Product Change Notification

Change Notification #: 117474 - 00

Change Title: Intel® Power Supply Unit FXX1600PCRPS, PCN 117474-00, Product Design, Label, Firmware upgrade

Date of Publication: March 10, 2020

PSU Label before (changes in red):

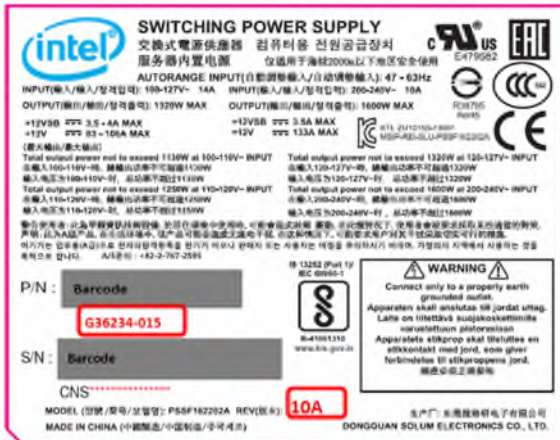
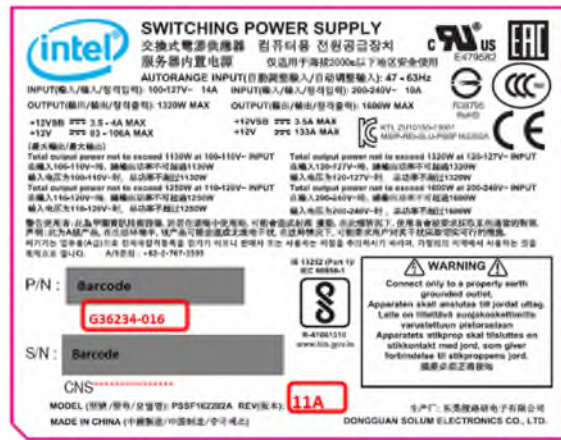
Intel is upgrading the Firmware the Power Supply Unit (PSU) showed in "Products Affected" table below from 77.9.128 to 78.9.128 in order to improve fan performance when operating at high temperatures. Labels of the product will be modified to reflect this change as shown below:

PSU Label after (changes in red):
